UNITED STATES  
NUCLEAR REGULATORY COMMISSION  
WASHINGTON, D. C. 20555

September 29, 1988

LICENSEE: Tennessee Valley Authority  
FACILITIES: Sequoyah Nuclear Plants, Units 1 and 2  
SUBJECT: MINUTES OF THE SEPTEMBER 15, 1988 MEETING WITH THE TENNESSEE VALLEY AUTHORITY (TVA) ON ITS MICROBIOLOGICAL INFLUENCED CORROSION PROGRAM AT SEQUOYAH

ISOMETRIC

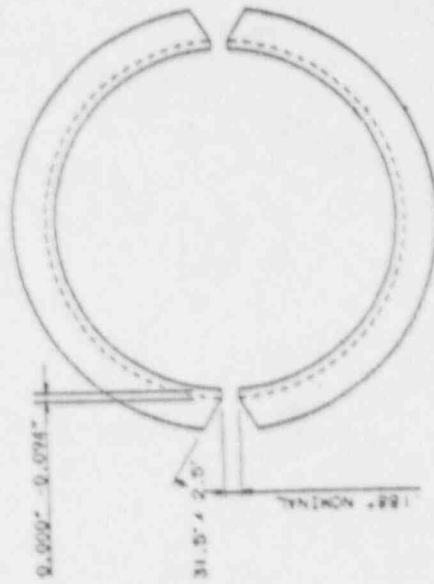
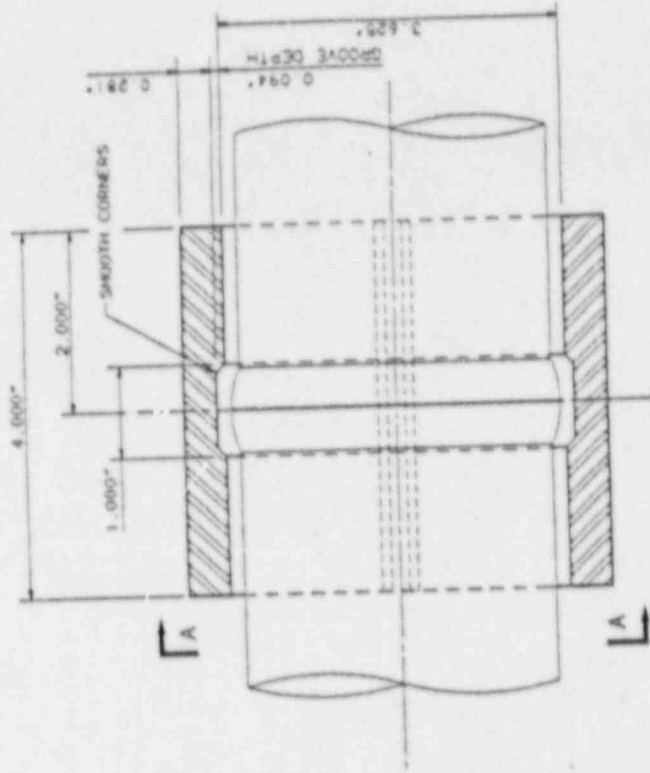
process if the MIC leakage criteria is exceeded and its contingency plan for installing a structural sleeve. The staff stated that it could not concur on the above based only on the meeting. The staff stated that TVA should submit the details of the MIC program at Sequoyah for the staff's review and approval.

INSTALLATION OF STRUCTURAL SLEEVE REQUIRES PRIOR NRC APPROVAL OF METHOD.

TVA HAS DEVELOPED A PREDESIGNED SLEEVE AS A CONTINGENCY FOR ERCW APPLICATION.

- . TO BE USED WHEN  $RF < 1$  BASED ON RT DATA AND OTHER REPAIR METHODS ARE NOT FEASIBLE FOR CONTINUED OPERATIONS
- . NOTIFY NRC RESIDENT
- . ENTER APPROPRIATE TECH SPEC ACTION
- . REPLACE PIPING SEGMENT AT NEXT REFUELING OUTAGE

- NOTES:
1. FOR 3" PIPE, FABRICATE A SLEEVE FROM 4" SCHEDULE 160 PIPE
  2. DIMENSIONAL TOLERANCE IS  $\pm 1/32"$
